RETREAT AT TIMBERRIDGE FILING NO. 3

COUNTY OF EL PASO, STATE OF COLORADO

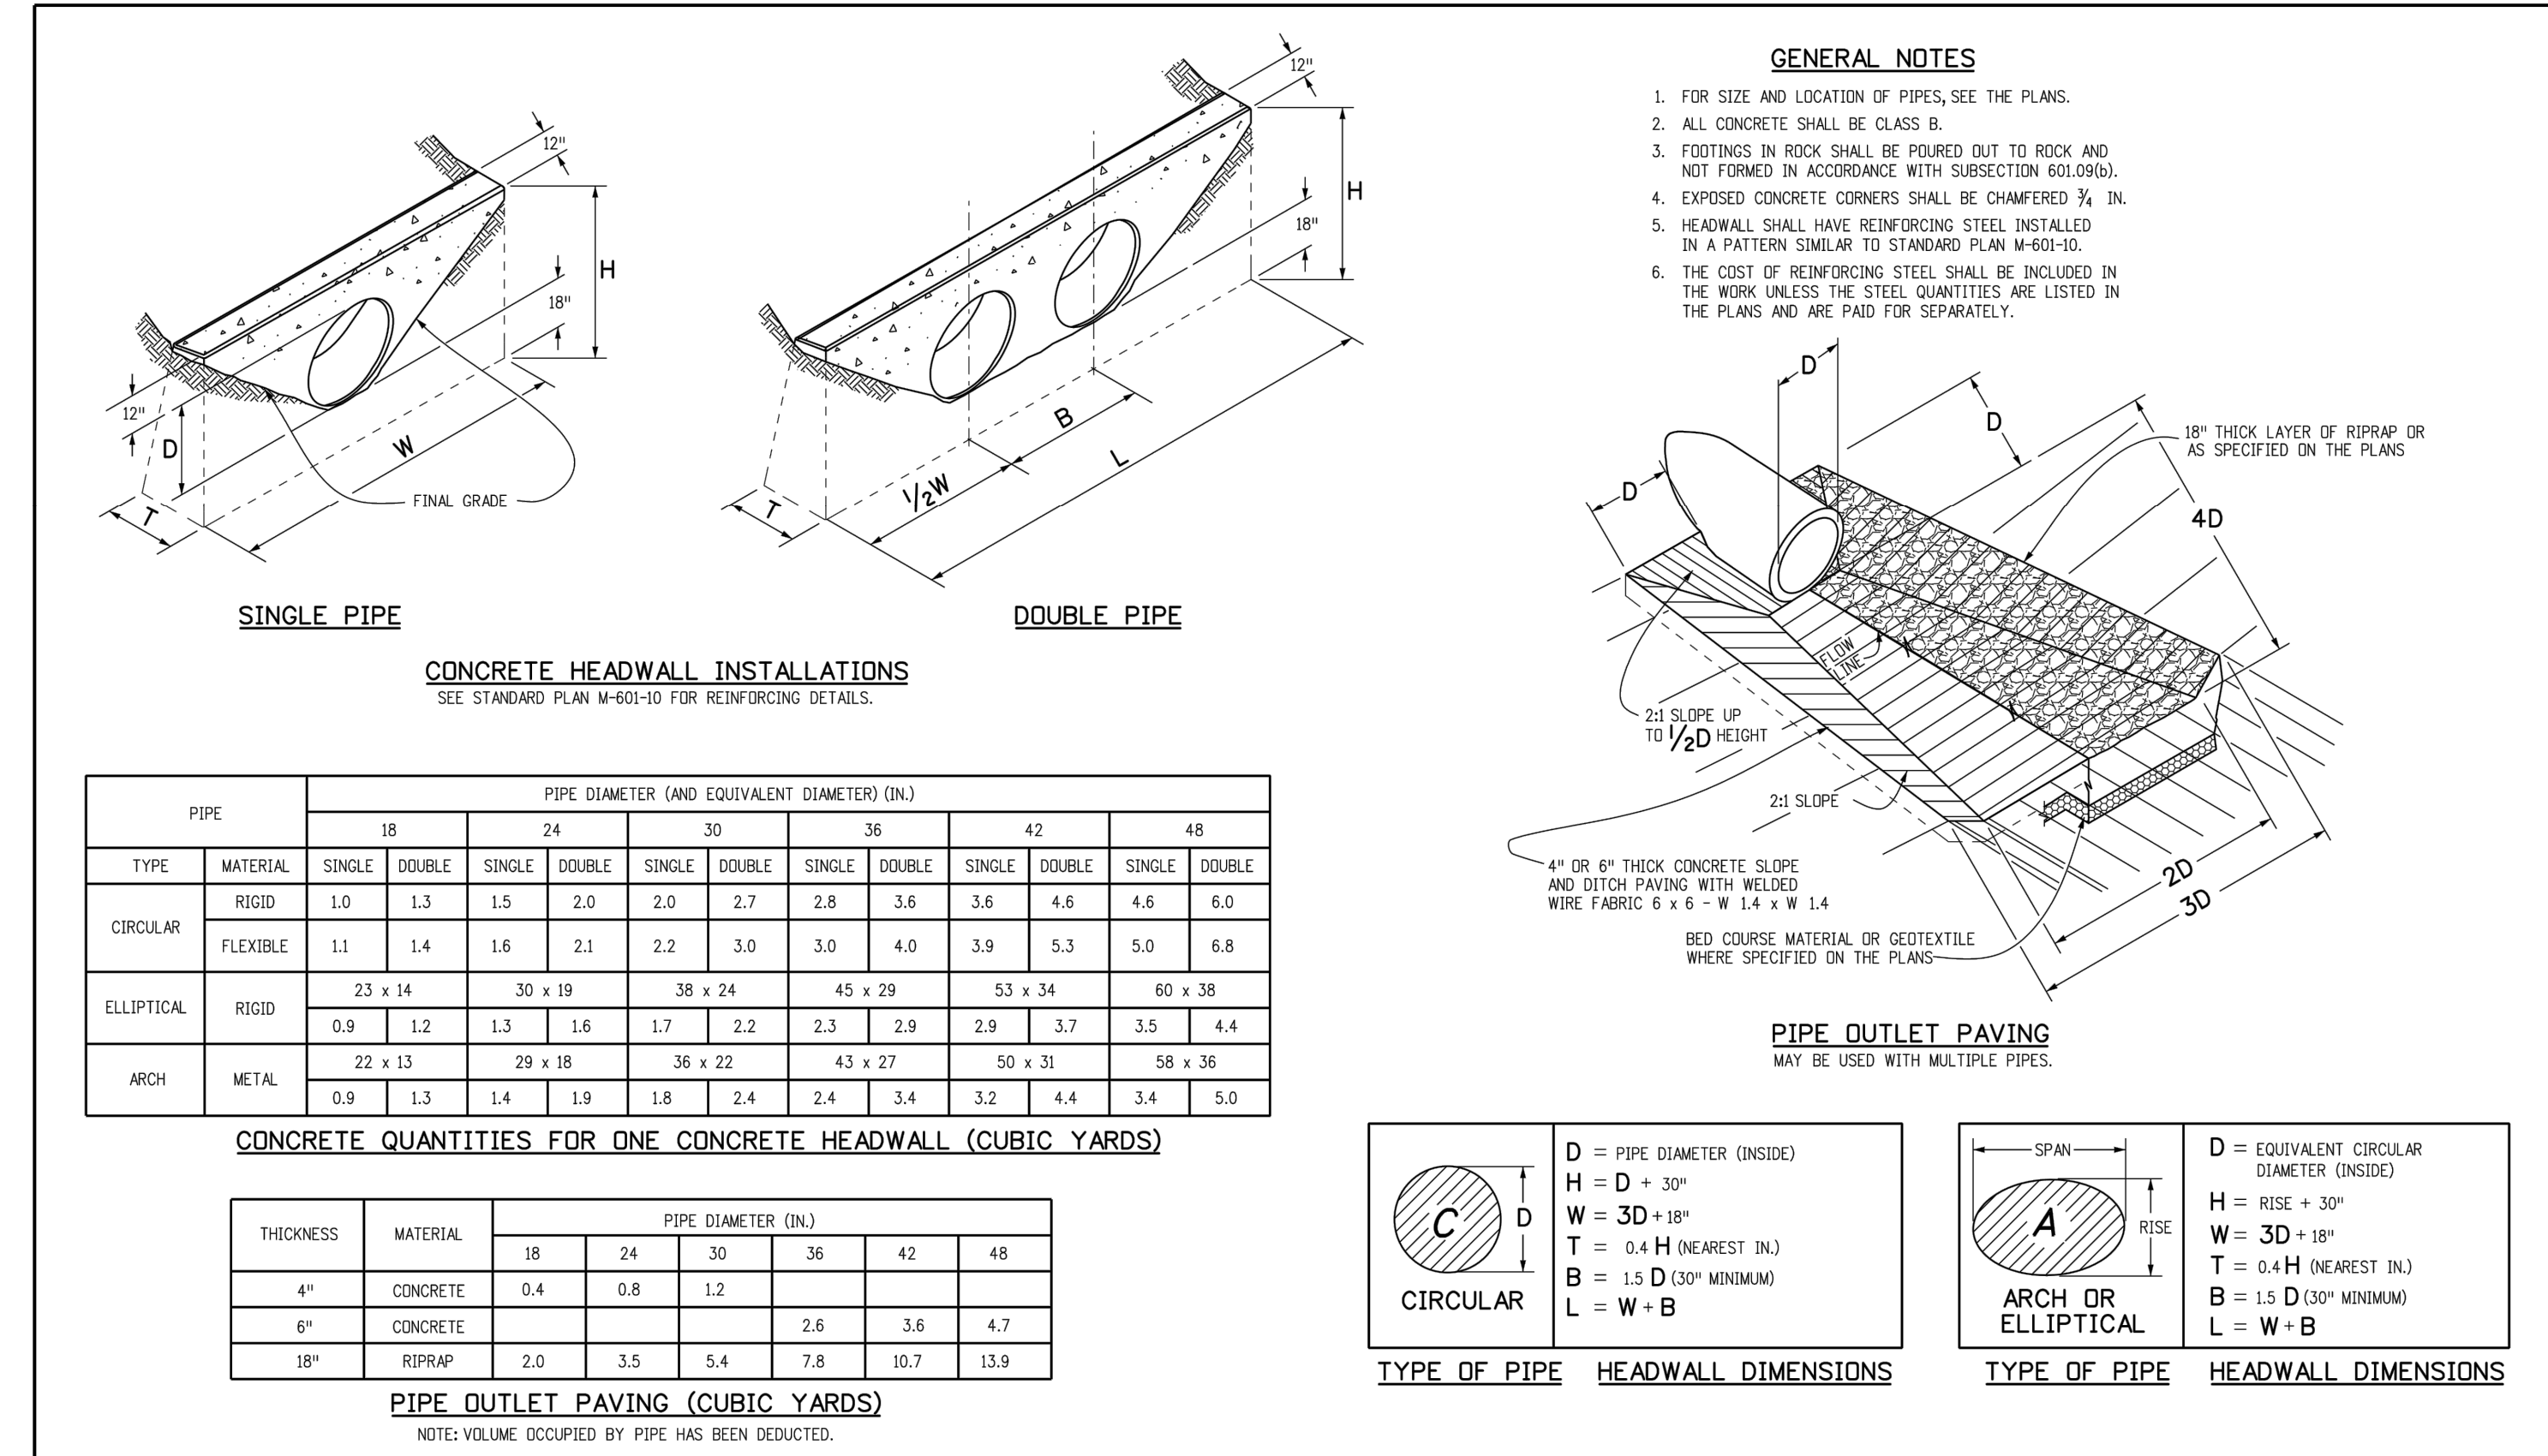
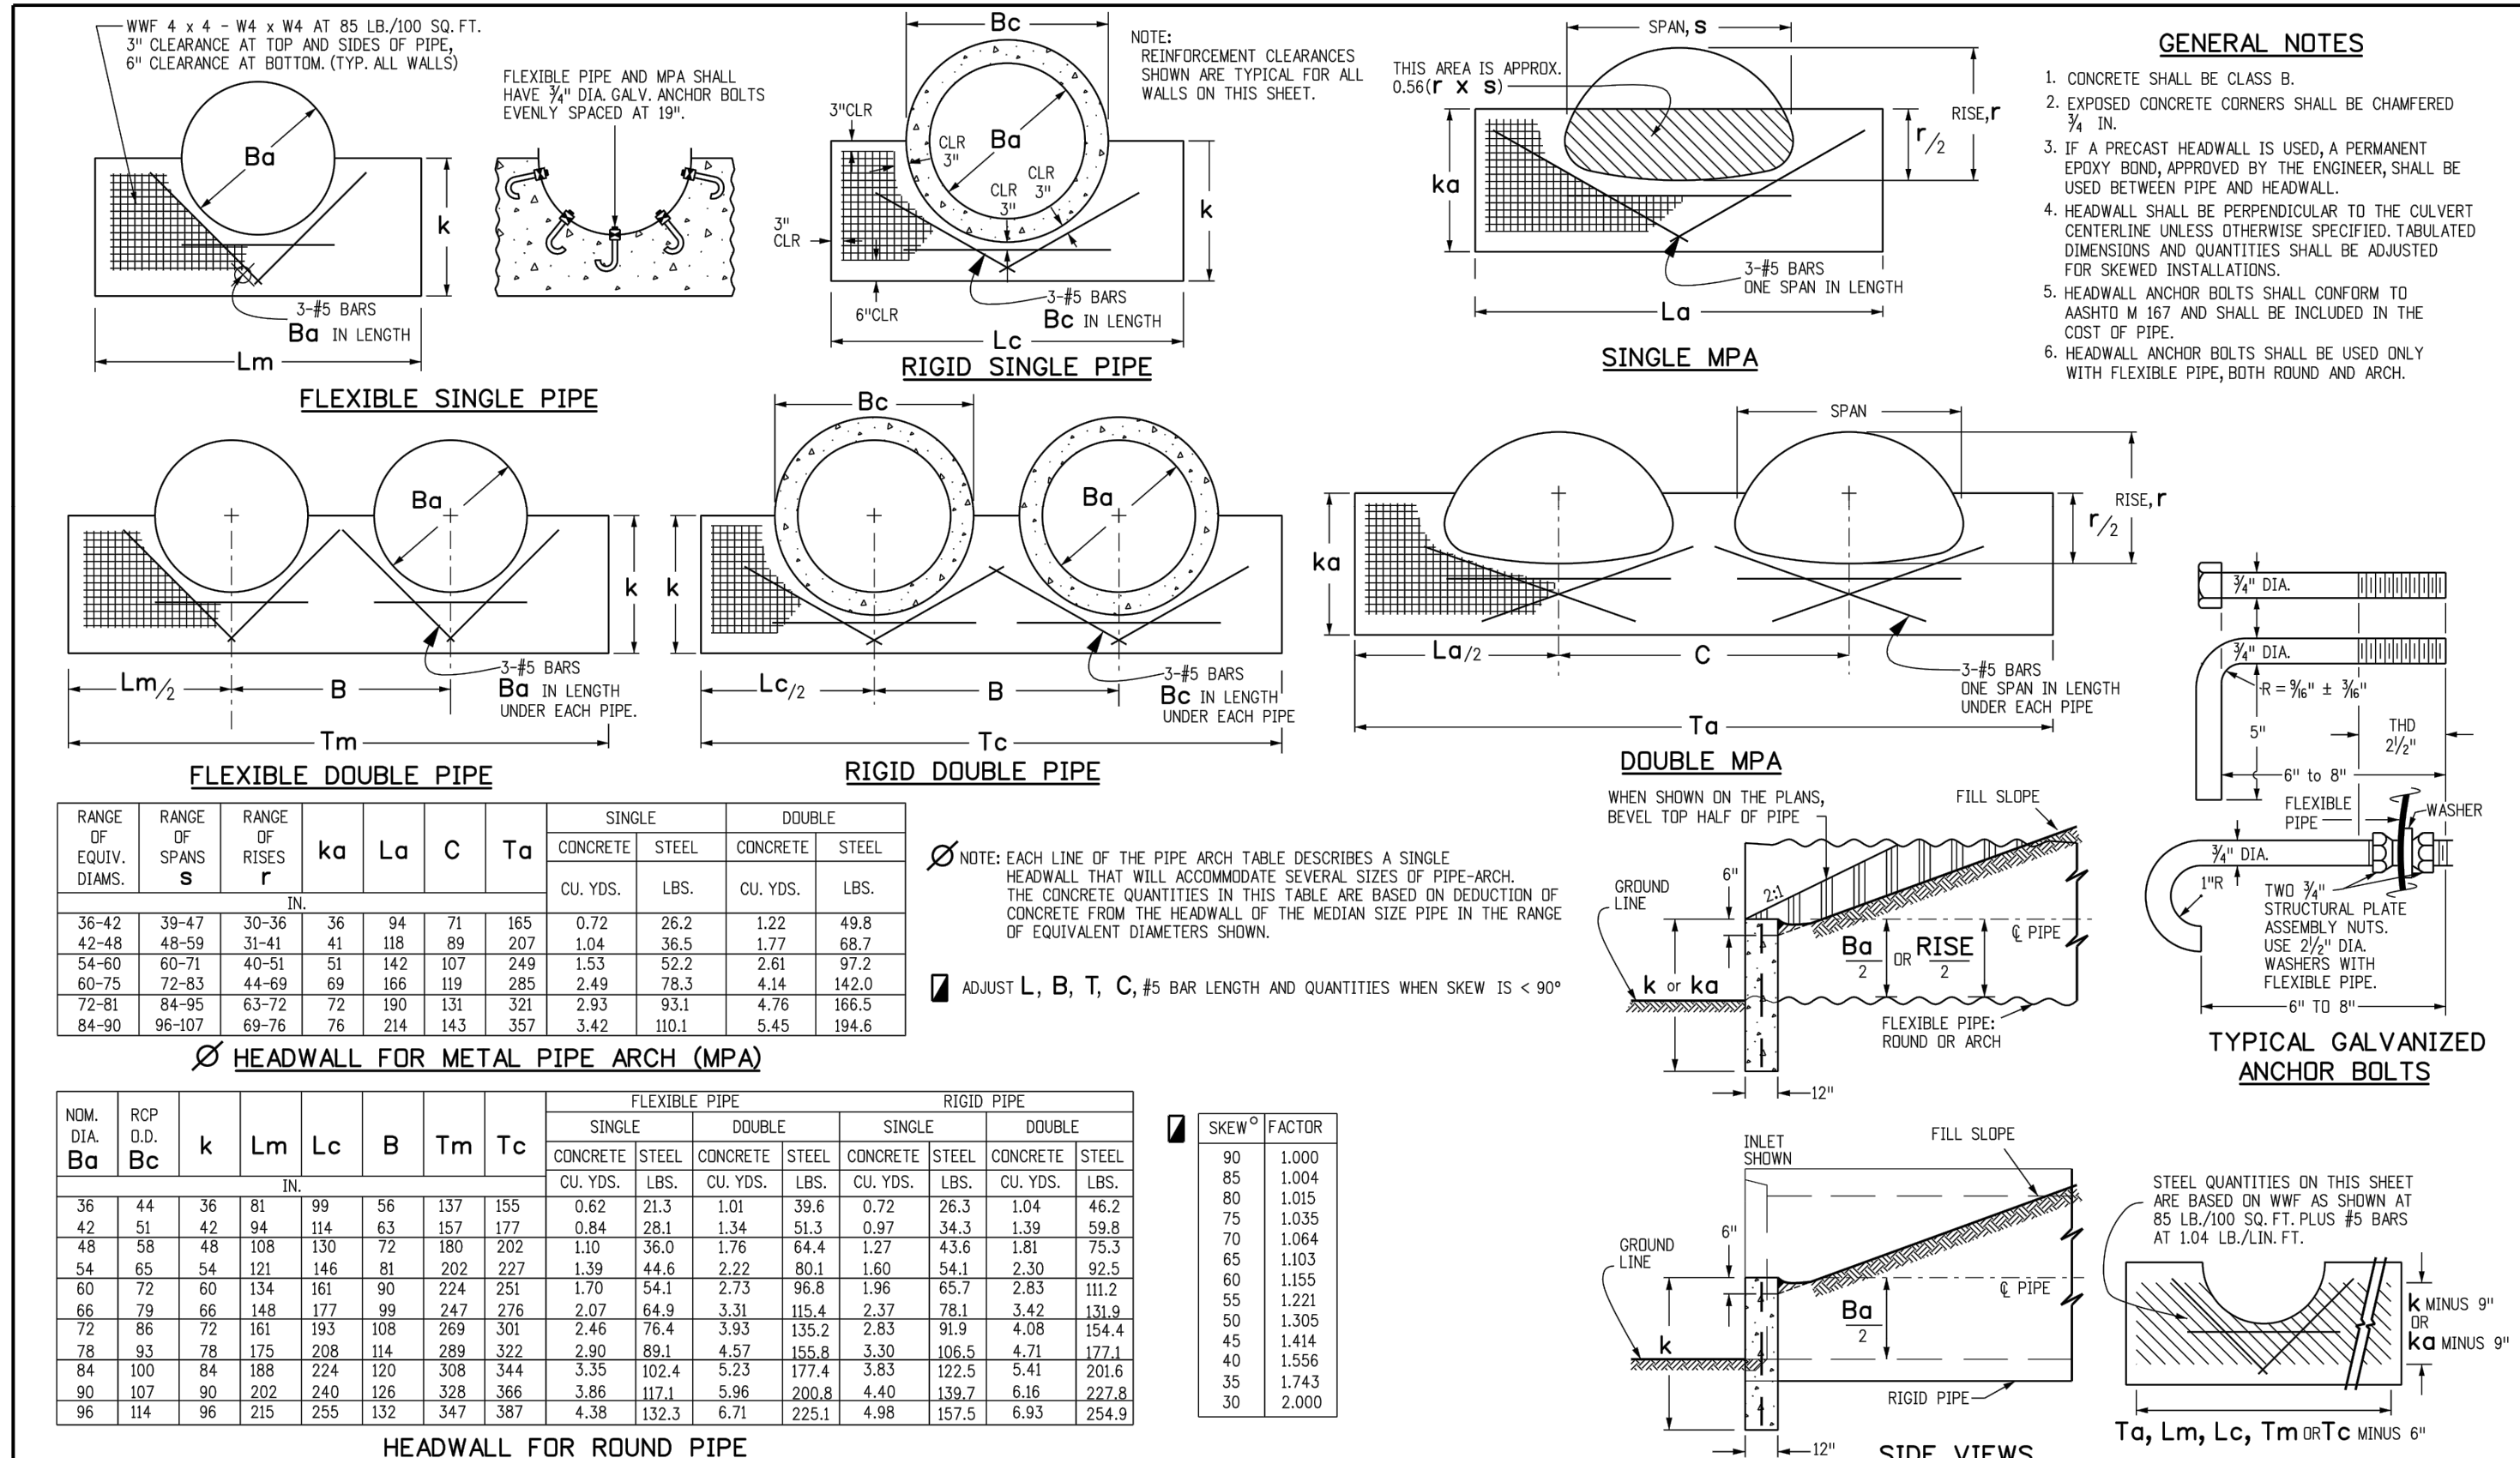
Computer File Information		Sheet Revisions		Colorado Department of Transportation		TYPE "S" SADDLE HEADWALLS FOR PIPE		STANDARD PLAN NO.	
Creation Date: 07/31/19	Designer Initials: JBK	Date:	Comments:	2829 West Howard Place	M-601-11		M-601-11		
Last Modification Date: 07/31/19	Detailer Initials: LTA			CDOT HQ, 3rd Floor	Standard Sheet No. 1 of 1		Standard Sheet No. 1 of 1		
CAD Ver: MicroStation V8	Scale: Not to Scale	Units: English		Denver, CO 80204	Project Sheet Number:		Project Sheet Number:

Computer File Information		Sheet Revisions		Colorado Department of Transportation		HEADWALLS AND PIPE OUTLET PAVING		STANDARD PLAN NO.	
Creation Date: 07/31/19	Designer Initials: JBK	Date:	Comments:	2829 West Howard Place	M-601-12		M-601-12		
Last Modification Date: 07/31/19	Detailer Initials: LTA			CDOT HQ, 3rd Floor	Standard Sheet No. 1 of 1		Standard Sheet No. 1 of 1		
CAD Ver: MicroStation V8	Scale: Not to Scale	Units: English		Denver, CO 80204	Project Sheet Number:		Project Sheet Number:
